Re: Interim Remedial Measure Modification Request
350 Grand Concourse, Bronx, NY 10451
NYSDEC BCP Site No. C203153

AKRF, Inc. (AKRF), on behalf of 350 GC Property Owner LLC (the "Volunteer"), prepared this Interim Remedial Measure (IRM) Modification Request Letter ("Letter") for the property located at 350 Grand Concourse, Bronx, New York (Site). The Site is also known as New York State Department of Environmental Conservation (NYSDEC) Brownfield Cleanup Program (BCP) Site No. C203153. A Site location map is provided as Figure 1.

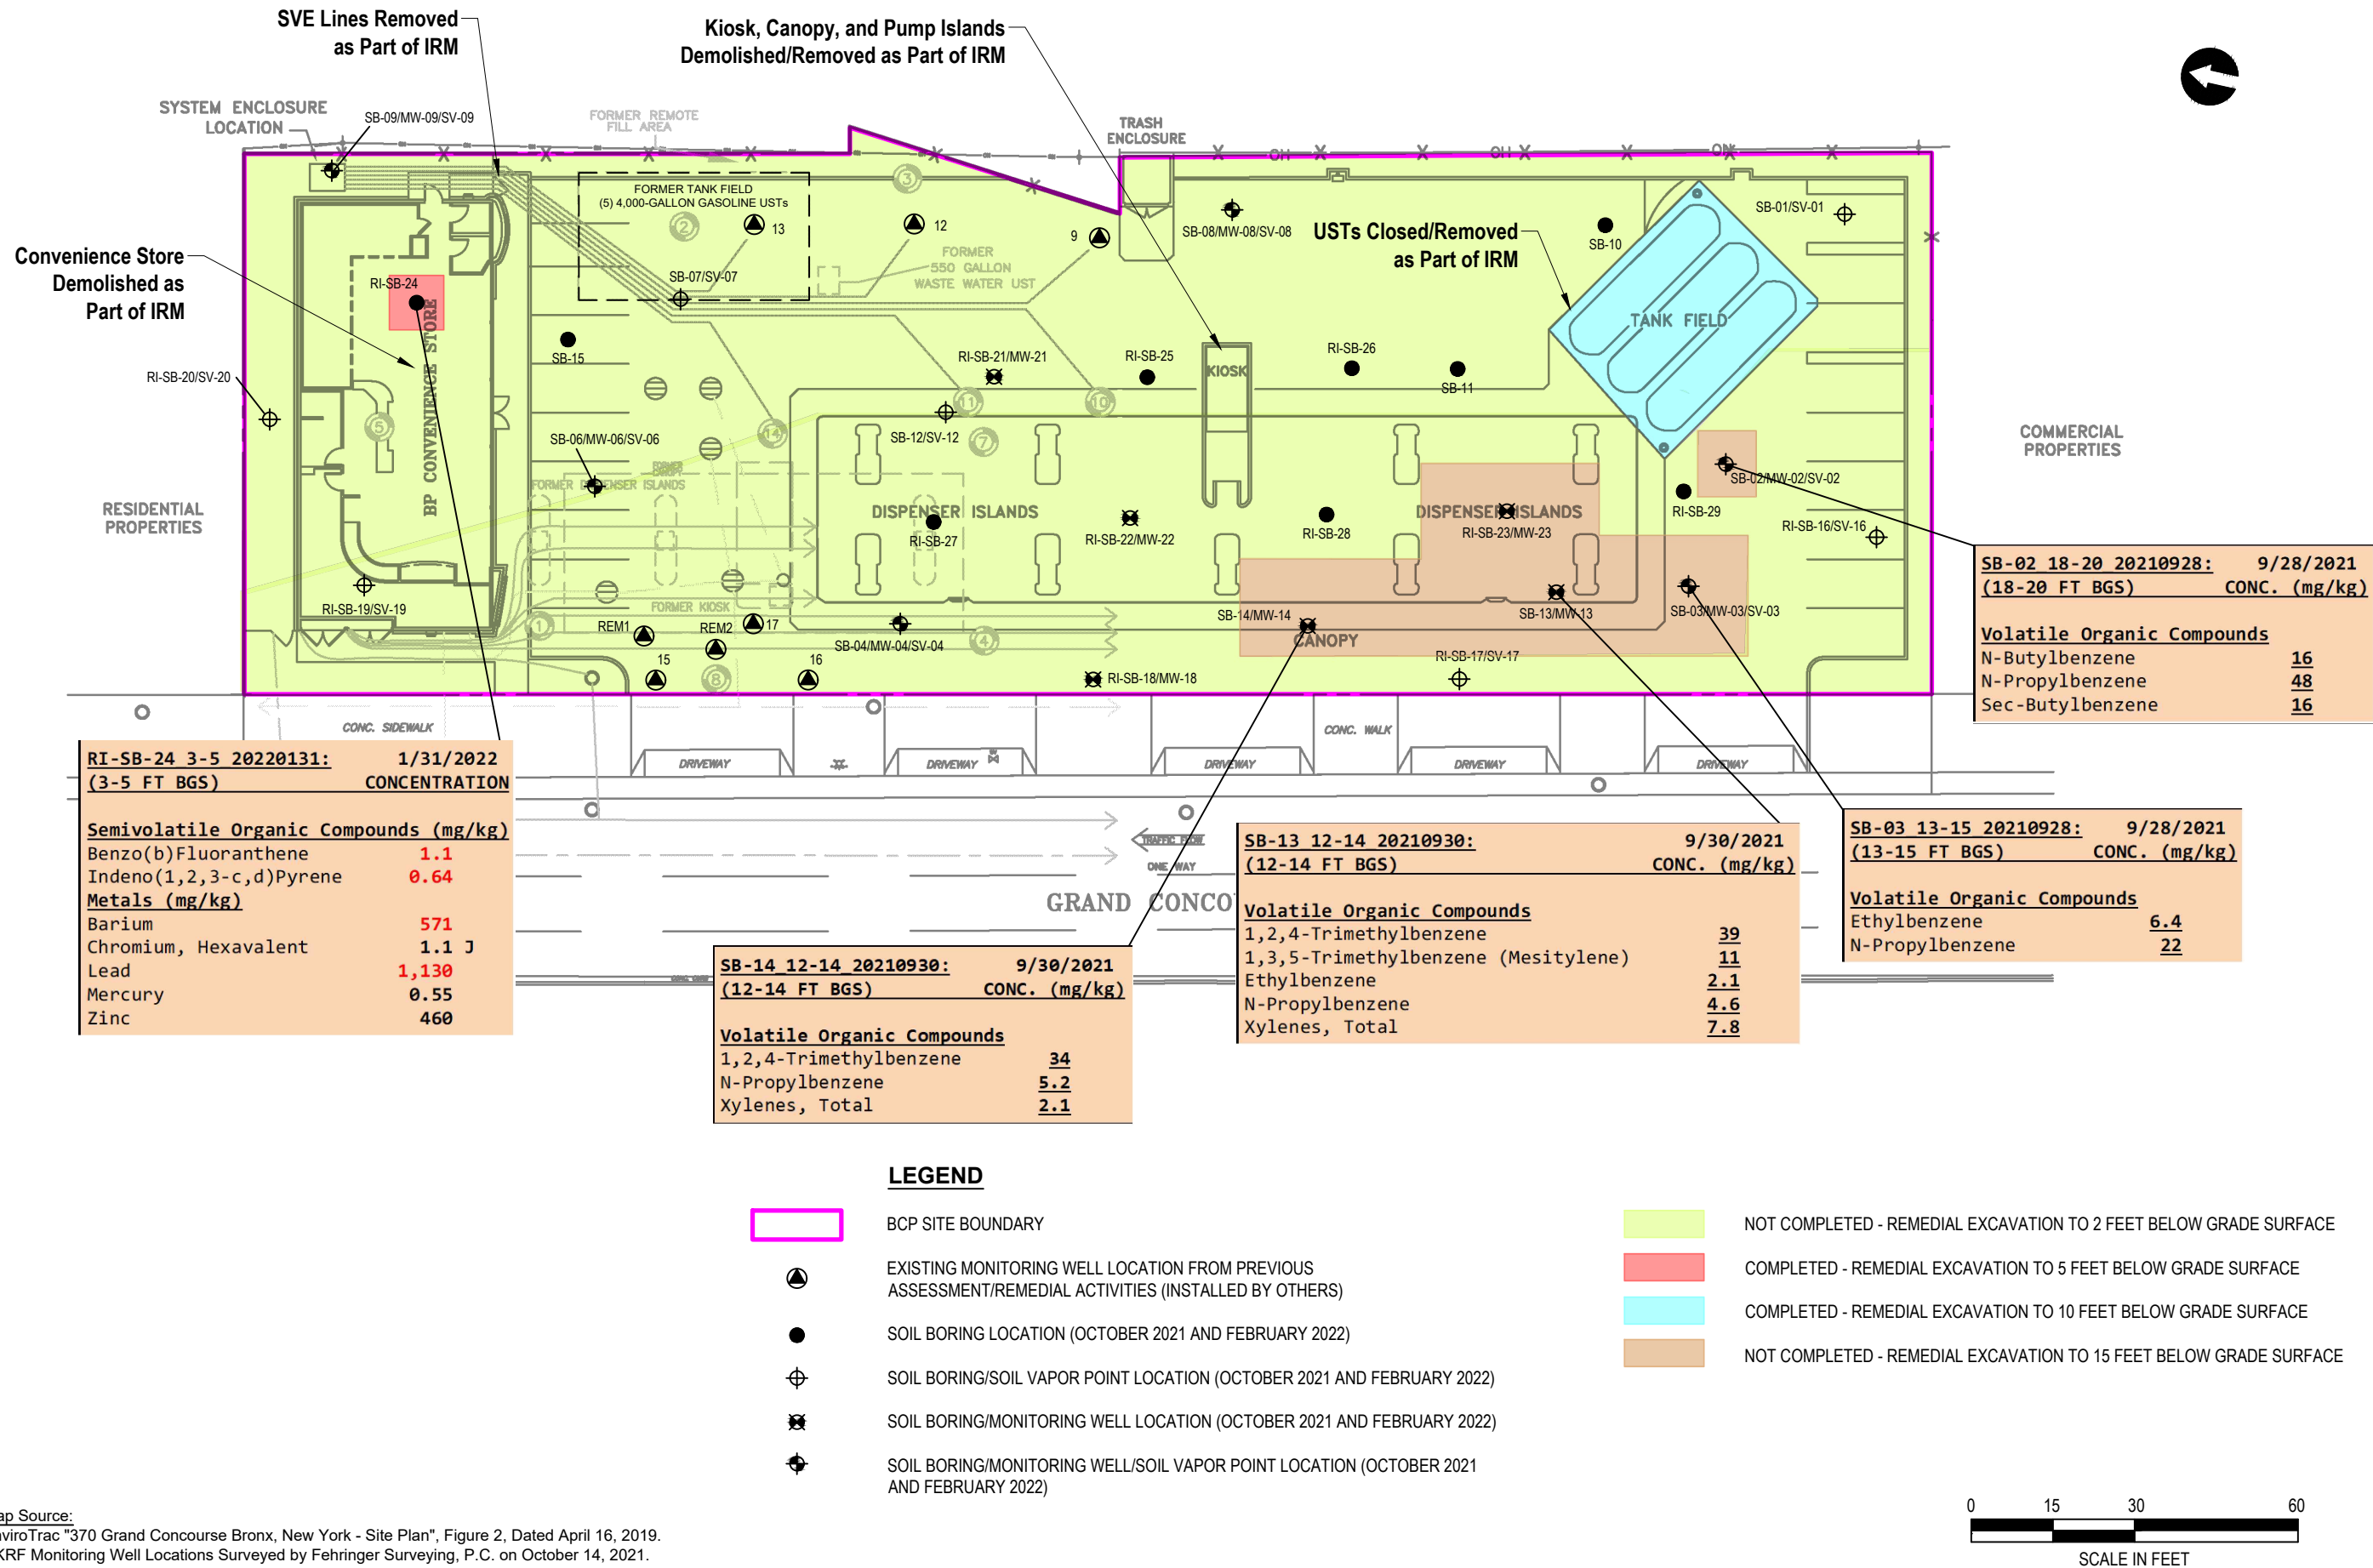
In addition to the excavations/removals discussed in Section 1, the 2022 IRMWP proposed the excavation and disposal of soil exceeding RRSCOs to a minimum of 2 feet below grade site-wide and additional excavation as necessary to remediate petroleum-contaminated soil (source material), as shown on Figure 2, which provides a current status of the excavations (whether they were completed in 2022 or currently remain incomplete). Furthermore, the 2022 IRMWP proposed implementation of an in-situ chemical oxidation program to treat contaminants in groundwater using an oxygen release compound at the base of excavations where grossly contaminated soils were encountered and/or

where petroleum-contaminated groundwater was located. The incomplete site-wide excavation to remove soil above RRSCOs to a minimum of 2 feet below grade, and the remediation of petroleum contaminated soil and groundwater will be deferred and will be defined in the future RAWP.
